**Information Document: Assessment of the Jabiluka Project: Report of the Supervising
Scientist to the World Heritage Committee**

This Information Document contains a review of scientific issues raised by the UNESCO mission to Kakadu National Park, Australia (WHC-99/CONF.204/INF.9A) as requested by the twenty-second session of the World Heritage Committee (Kyoto, Japan 30 November – 5 December 1998)

Assessment of the Jabiluka Project

Report of the Supervising Scientist

Figure 3.3.1 Comparison of average monthly storage evaporation estimates and point potential and areal potential evapotranspiration rates

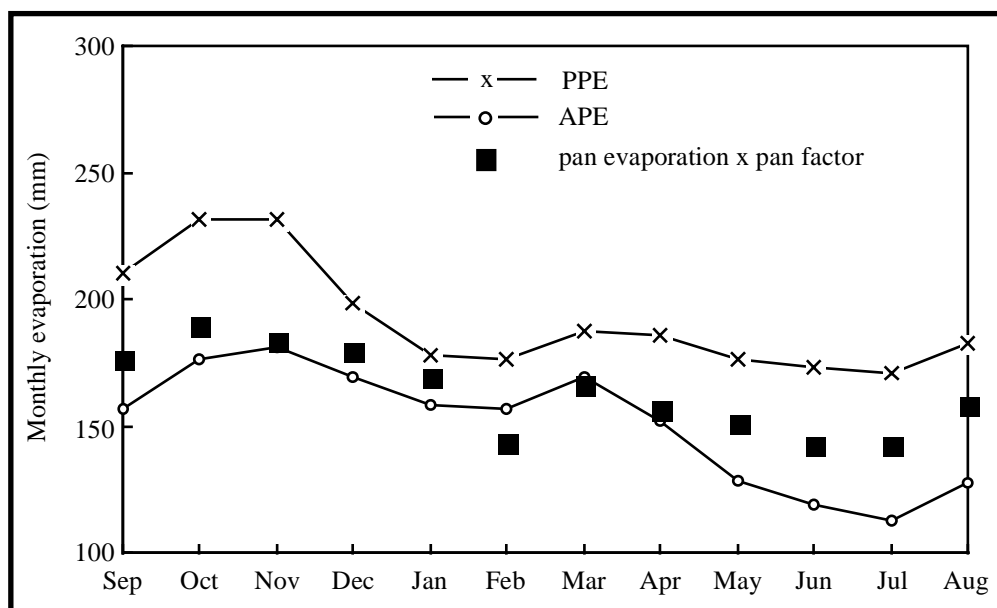
Wasson et al (1998) note the use by ERA of two simple seasonal factors to estimate pond evaporation from pan measurements; 0.6 in the Dry season (May–October) and 0.75 in the Wet season (November–April). They assert that there is a need to check these factors by appropriate modelling that incorporates existing solar radiation data and that the extensive evaporation study conducted at Manton Dam, south of Darwin, needs to be taken into account.

The approach outlined above was adopted by ERA in the draft EIS in 1996 but Wasson et al (1998) seem to have been unaware that ERA adopted a more sophisticated approach in the PER for the Jabiluka Mill Alternative. It was the proposal for the Jabiluka Mill Alternative, presented in 1998, which was the subject of investigations conducted by the Mission of the World Heritage Committee to Kakadu. ERA outlined in Appendix B1 of the PER the procedure adopted in estimating evaporation from the retention pond. Pan factors for each month of the year were adopted following a review of all existing evaporation data relevant to the region by CSIRO (Hatton 1997). The conclusion of Hatton (1997) was that, with the exception of the two months of April and October, the pan factors derived by the Supervising Scientist (Vardavas 1987) should be used in all water balance calculations.

Figure 3.3.1 shows the evaporation rates calculated using the Vardavas (1987) pan coefficients and these are compared to the APE and PPE values. All of the Vardavas calculations are in agreement with the seasonal pattern of the APE and the PPE. For February and March, the estimated storage evaporation rates are lower than the APE and Chiew and Wang (1999) concluded that this could be due to errors in the recorded pan evaporation (because of the difficulty in accurately estimating pan evaporation when rainfall is high) or errors in the APE estimates. The overall conclusion was, however, that the best estimates of pond evaporation for Jabiluka would be obtained by using the results of Vardavas (1987).

Figure 3.3.2 Relationship between evaporation and rainfall at Jabiru for the months of January, February and March

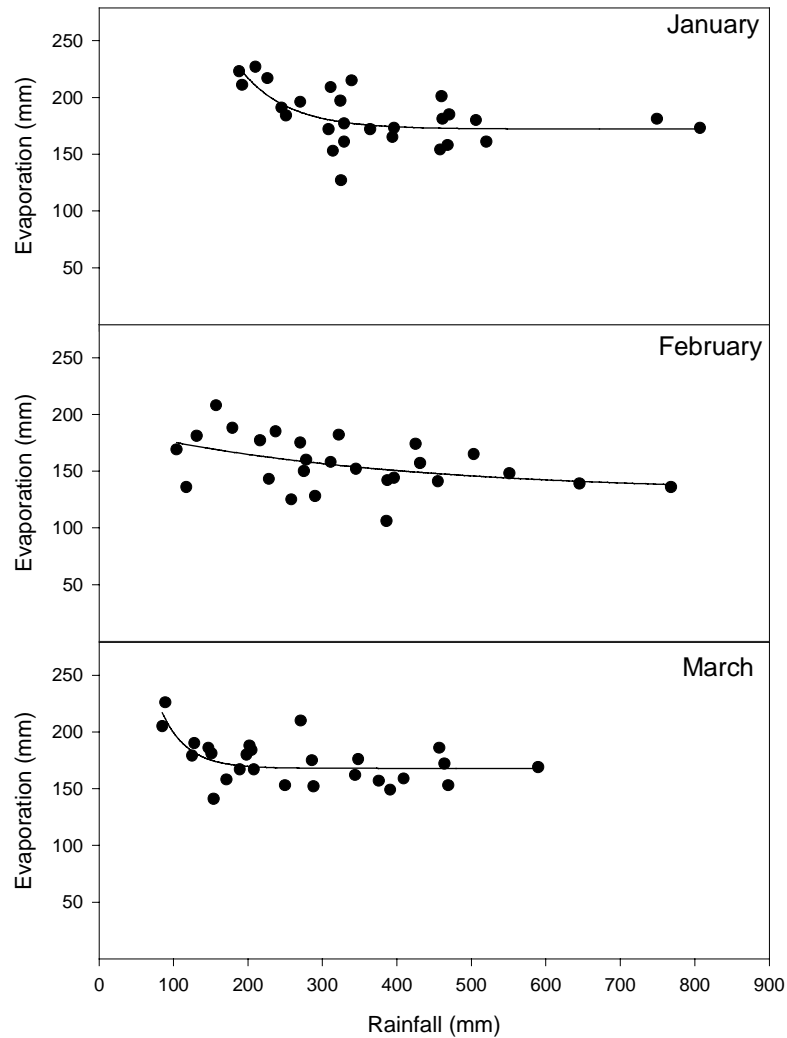
Wasson et al (1998) state that the principal source of error in the evaporation calculations of ERA arises from neglect of the inverse relationship between evaporation and rainfall which arises because solar radiation is lower on cloudy days than on sunny days. They suggest that the adoption of long-term mean values for the pan factors will result in a significant over-estimate of evaporation in very wet months and that this effect could exceed 10% during very wet years.

Chiew and Wang (1999) investigated the significance of the inverse relationship between evaporation and rainfall using data from a number of meteorological stations in the north of the Northern Territory including Jabiru, Maningrida, Middle Point and Darwin. They found that a linear inverse relationship was statistically significant for both the annual data and the quarterly data at each station and that it was most significant at Jabiru. They concluded that this effect should be taken into account in their modelling of the water management system at Jabiluka and they evaluated the significance of the effect on the required pond volume. The conclusion reached was that the retention pond volume would need to be increased by about 3% as a result of both the inverse relationship and interannual variability in evaporation.

There is, however, evidence that even this small effect is an over-estimate because, during the principal months of the Wet season (December to March), cloud cover is often extensive even when there is no rainfall. As a result, the relationship between evaporation and rainfall during any given month will not be linear but evaporation will tend towards a constant lower value at higher rainfall values. This effect is clearly illustrated in figure 3.3.2 where evaporation at Jabiru is plotted against rainfall for the principal Wet season months of January, February and March. The line through the data in each case is of the form

Figure 3.4.1 Variation of saturated vapour pressure (upper graph) and absolute humidity (lower graph) with temperature at atmospheric pressure P=100kPa

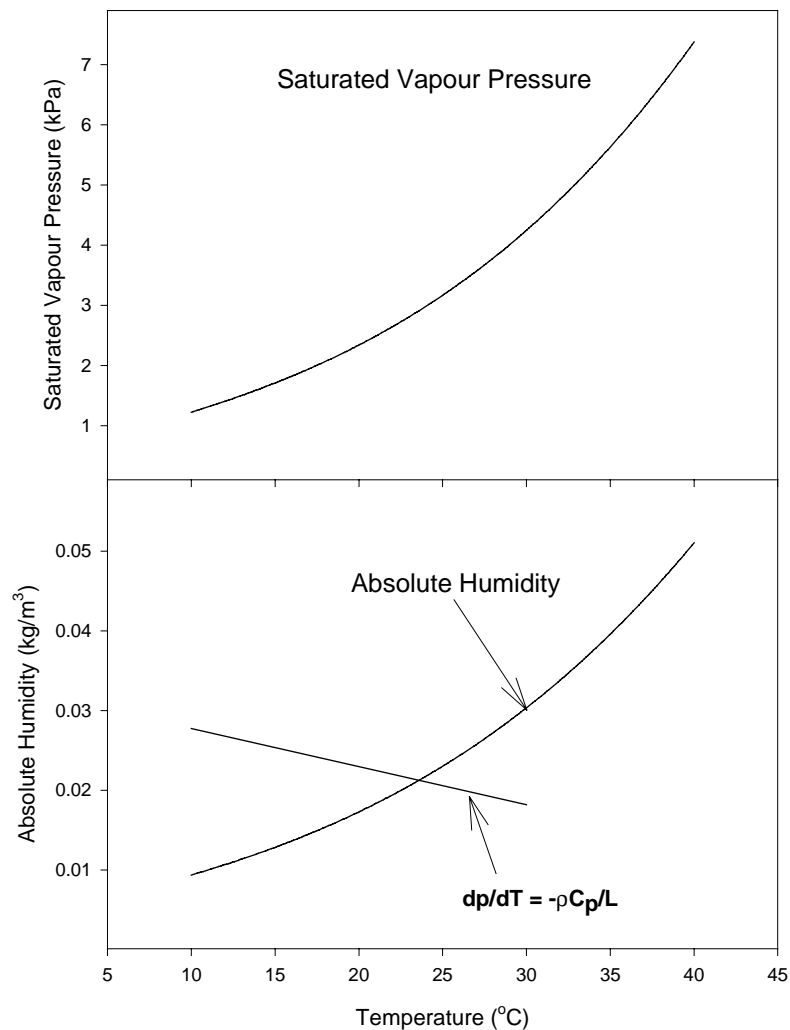
where Δp is the change in humidity, L is the latent heat of vaporisation, ρ is the density of air and C_p is the specific heat of air. Using $L = 2.43 \cdot 10^6 \text{ J/kg}$ (Kaye & Laby 1978, p 235), $\rho = 1.149 \text{ kg/m}^3$ (Kaye & Laby 1978, p 18) and $C_p = 1010 \text{ J/kg}^\circ\text{C}$ (CRC 1995, p 6-1), the decrease in temperature resulting from the vaporisation of the water would be 16°C . As can be seen from figure 3.4.1, the absolute humidity (ie fully saturated) at 14°C is about 0.012 kg/m^3 , a figure considerably less than the initial vapour density. Hence, the target evaporation figure cannot be achieved.

For 60% relative humidity, $p_0 = 0.0182(\text{kg/m}^3)$ at $T_0 = 30^\circ\text{C}$. This line is shown in figure 3.4.1. It intercepts the graph of absolute humidity at about 23.6°C which, as proposed by Wasson et al (1998), is the wet bulb temperature (estimated as 23.8°C from the data in CRC (1995) p15–22). At this temperature the absolute humidity is $0.0213 (\text{kg/m}^3)$. Thus the maximum quantity of water that can be evaporated is

This value is about 40% of the design value presented in Appendix J of the draft EIS.

These observations, however, do not imply that a major error exists in the proposal put forward for water management at the Jabiluka mine. If the latent heat of evaporation were to be supplied (for example, by standard humidifiers) there would be no need to take the above drop in temperature into account and the volume of water that could be evaporated would remain that estimated in the EIS and the PER. The Supervising Scientist consulted the engineer who advised ERA on this issue (Mr Douglas Rudd, Kinhill Pty Ltd) who advised that the calculations were provided to indicate the capacity of the ventilation system to dispose of additional water through evaporation. It was recognised that energy input via heaters, hot air blowers or staged misting/humidifiers would be required to achieve the full indicated disposal volume. These issues were, however, matters to be dealt with at the detailed design stage of the project when the potential of this method of water disposal could be evaluated (ie a cost benefit analysis) in a comparison with other methods such as increasing the area of the retention pond.

The area of the retention pond would need to rise from 9 ha to approximately 13 ha to provide the required evaporative capacity if no evaporation occurs in the ventilation shafts. This area is small compared to the total area of retention and tailings ponds proposed in the original JMA proposal and is only 2% of the disturbed area at the nearby Ranger mine. The environmental impact arising from such an increase, should it need to be part of the project, is, therefore, not considered to be significant.

Figure 4.4.1 Cusum plot for the annual rainfall records at Oenpelli showing low average rainfall from 1932–1952 and high average rainfall from 1970–1984

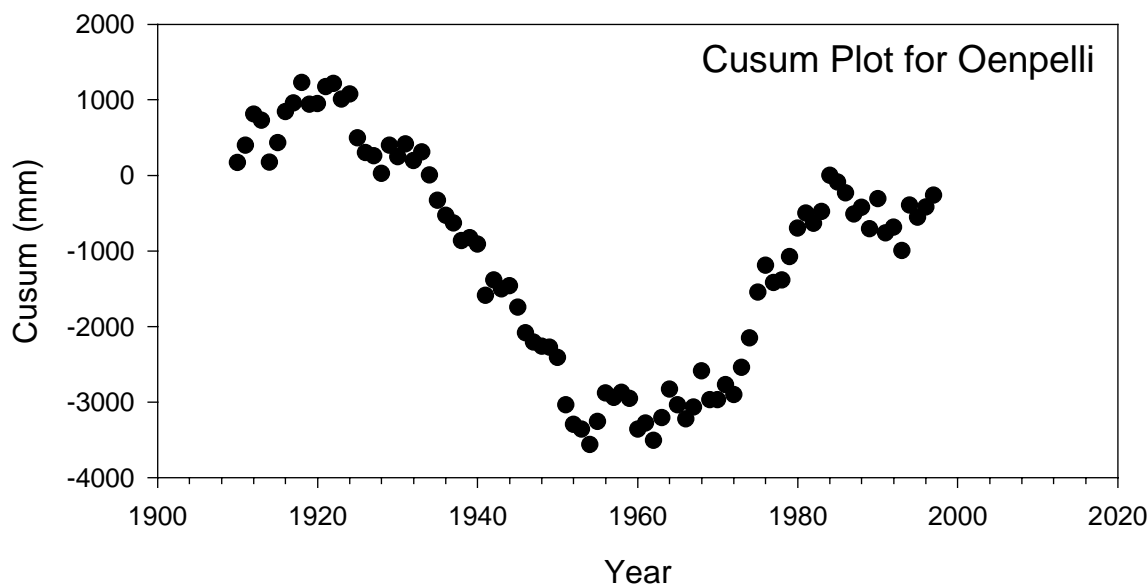
Thus, the response by ERA that greenhouse induced changes were not expected to be significant for hydrological modelling over the next 30 years has some justification because all of the coupled ocean models, which are considered to be more realistic, predicted a reduction in Wet season rainfall. However, until regional climate models are incorporated into the global climate models, this conclusion should be considered preliminary.

The *cusum* analysis for the Oenpelli data set, including rainfall records from 1991–1998, is shown in figure 4.4.1. It can be shown (eg Mittag & Rinne 1993) that the gradient of the *cusum* graph at time t is the difference between the mean at that time and the long-term mean. The data in figure 4.4.1, therefore, show that, at Oenpelli, there have been two extended periods in the past 87 years during which the mean annual rainfall for the period has been significantly different from the long-term mean annual rainfall. From 1932–1952, the mean rainfall was about 1220 mm, lower than the long-term mean by about 13%. From 1970–1984 the mean rainfall was about 1600 mm, higher than the long-term mean by about 15%. It is clear that such decadal-scale variation in mean rainfall could have a significant impact on

Figure 5.2.2 Annual rainfall (September – August) and accumulated water volumes for a model simulation using actual rainfall and evaporation from September 1972 to August 1998

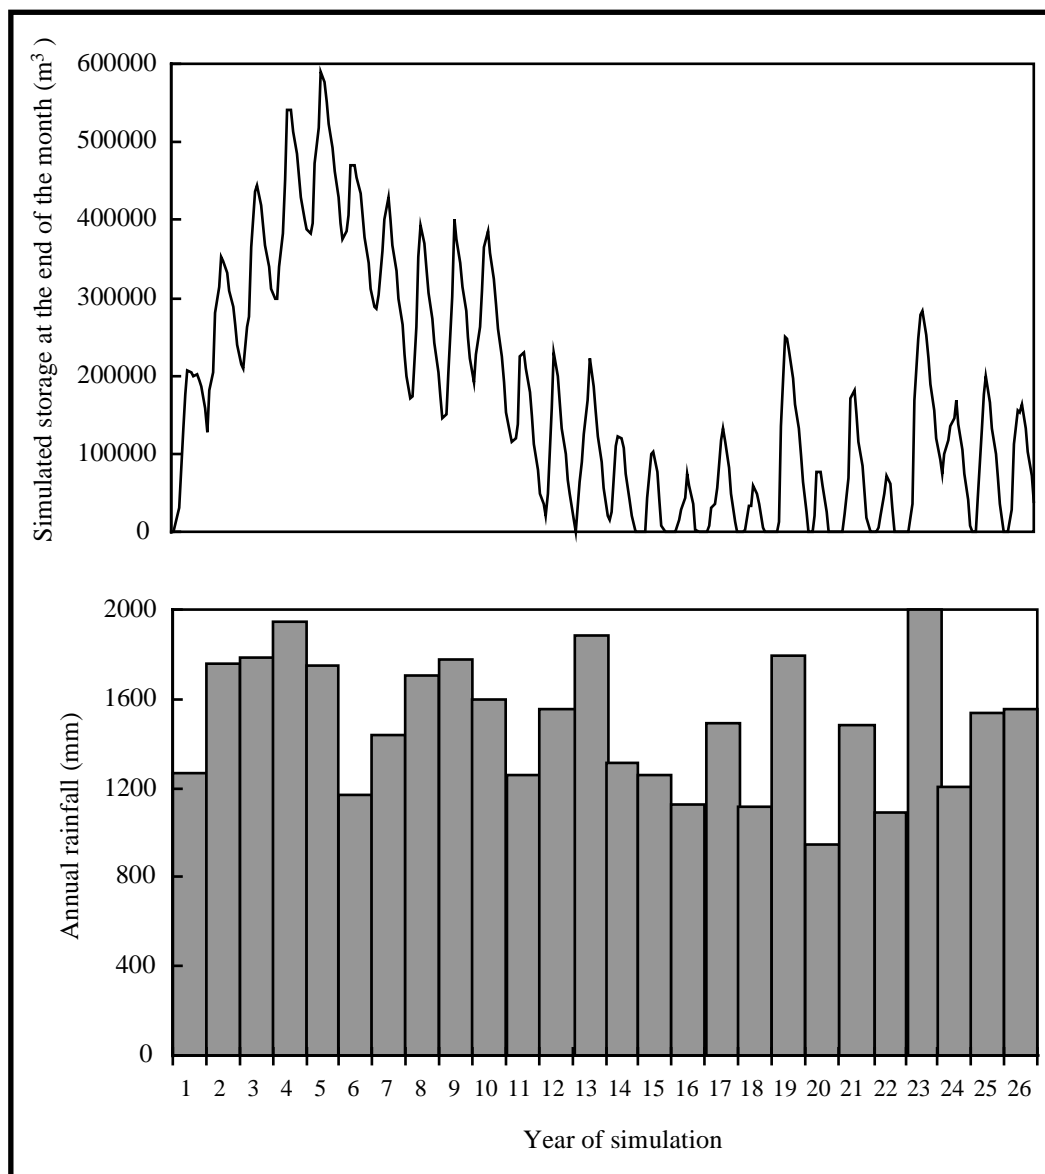
Evaporation in the ventilation system was examined in section 3.4. It was shown there that, unless an expensive humidifier system is installed, the maximum loss by evaporation in the ventilation system would be about 40% of the value proposed in the EIS and the PER. It was suggested that this deficiency could be overcome by increasing the area of the retention pond

by about 4 ha, thus increasing its evaporative capacity. If this suggestion were to be implemented, then the full additional evaporative capacity of 90,000 m³ would be available as soon as water covers the base of the retention pond. By year 5 of operation, the difference in accumulated water losses from the water management system between this scenario and that outlined in table 5.2.4 is about 300,000 m³. Hence, the maximum storage capacity required in the simulation illustrated in figure 5.2.2 would be reduced by about 50%. Similarly, it is likely that if the full simulation of the water management system were repeated using pond evaporation rather than evaporation in the ventilation system, the capacity required to achieve an exceedence probability of 0.01% over the life of the mine (see section 5.2.3) would be reduced by about 30%.

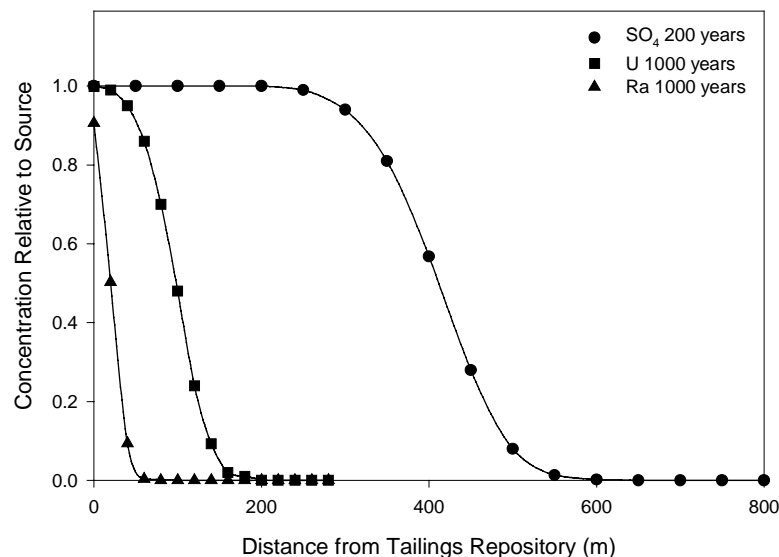
The transport of solutes to the west is calculated to be somewhat more rapid because of the greater permeability of the aquifer there. The velocities east of the divide in the sandstone are between 5×10^{-5} and 5×10^{-6} m/day, whilst in schists to the west the range is 5×10^{-4} to 5×10^{-5} m/day. The results obtained for the migration of sulphate, uranium and radium to the west are shown in figure 6.3.6. These data indicate a probable migration distance of 500 m after 200 years for sulphate, although greater distances are possible (Kalf & Dudgeon 1999). Again, the three dimensional solute transport model shows that for a tailings permeability of 10^{-9} m/s, the sulphate 'source' concentration immediately downstream from the mine void tailings would be about 2000 mg/L. The data in figure 6.3.6 show that the median concentration of sulphate would drop to less than 20 mg/L about 500 m downstream. This water would be entering an area of already very poor quality water (see section 6.3.1) where natural sulphate concentrations are in the range 1500–7000 mg/L so that the impact of the migration of water from the tailings repository would be negligible. In addition, the floodplain is underlain by low permeability clays (East et al 1992) which act to limit any potential upflow of the groundwater into surface waters.

The data in figure 6.3.6 indicate that uranium is likely to travel up to 200 m in a westerly direction at which point the concentration would be reduced to less than 1 mBq/L, a concentration that is significantly less than natural concentrations in the region. The Monte
